SUBJECT: Final Environmental Assessment (FEA)/ Finding of No Significant Impact (FONSI) for the Hilton Corporation Duke Kahanamoku Lagoon Restoration Project Located at Waikiki, Oahu, Portions of TMK: (1) 2-3-037:012 & 021; (1) 2-6-009:002 & 010; and (1) 2-6-008:034

*Final Environmental Assessment &
Finding of No Significant Impact*

**DUKE KAHANAMOKU LAGOON
RESTORATION PROJECT**

**WAIKIKI BEACH AT THE HILTON HAWAIIAN VILLAGE,
HONOLULU, O'AHU**

Figure 2-1:
Plan View of Reconfigured Lagoon

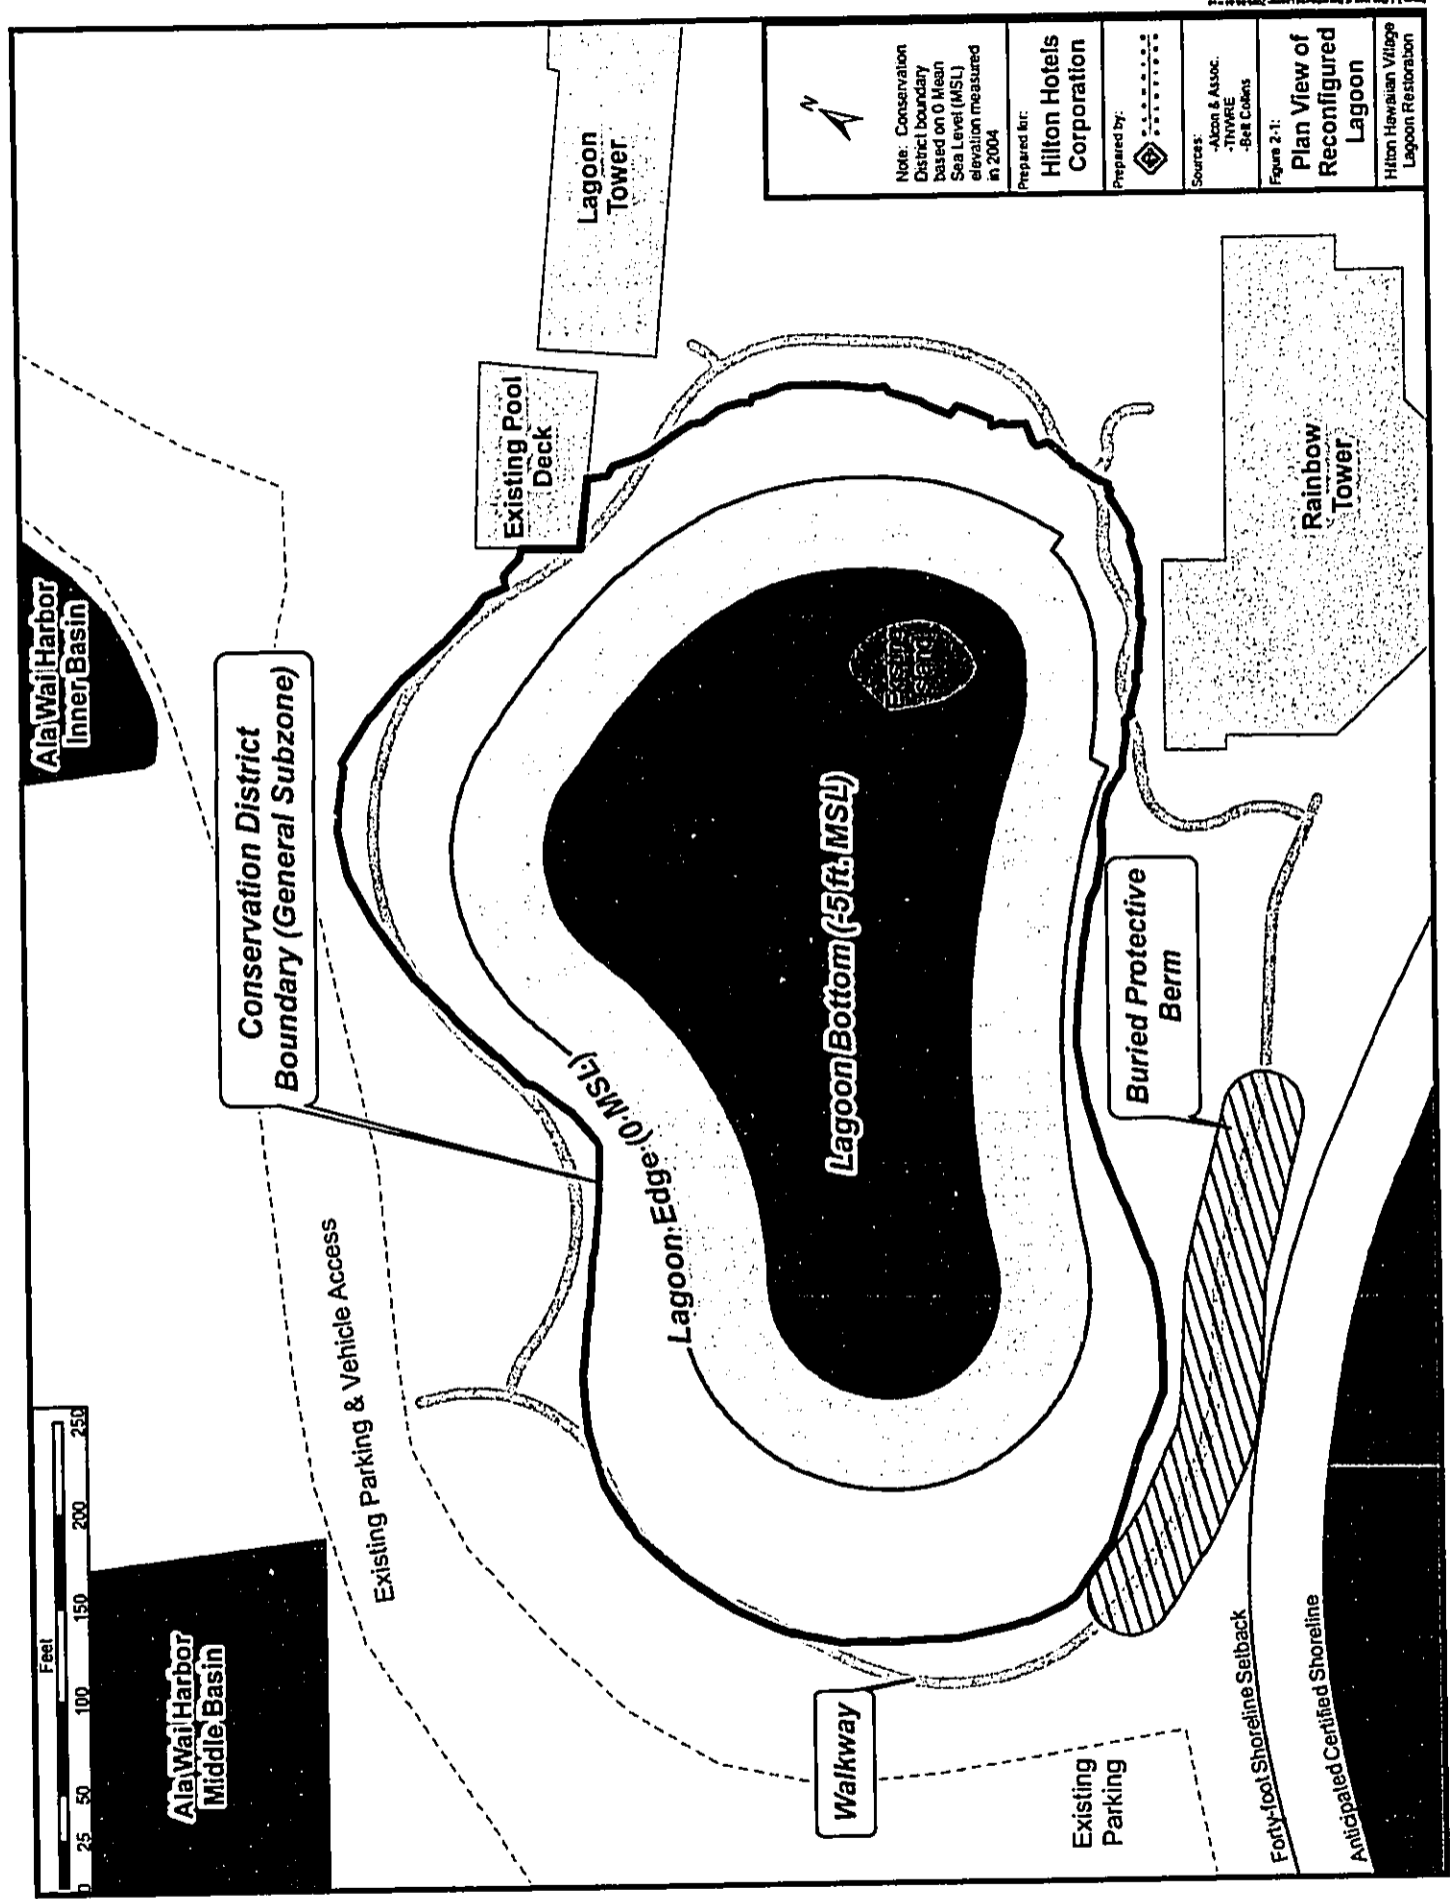
Figure 2.1 illustrates that the proposed buried protective berm will be located just beyond the (forty) 40-foot shoreline setback established by an "anticipated" certified shoreline. The easternmost four hundred (400) feet of the proposed Waikiki Promenade extension would be situated atop the beach berm separating the lagoon basin from Kahanamoku Beach. Note that the berm and promenade may require a shoreline setback variance should the actual certified shoreline differ from the anticipated certified shoreline, or if the location of the berm or promenade is within the shoreline setback.

2-4 Figure 2-1 shows the Conservation District Boundary around the lagoon. We suggest that the Conservation District subzone designation be added to the label for this feature, as subzone designation is used to determine certain waterbody classes under Hawaii Administrative Rules Chapter 11-54.

Page 2-4: Figure 2-1 shows the Conservation District Boundary around the lagoon. We suggest that the Conservation District subzone designation be added to the label for this
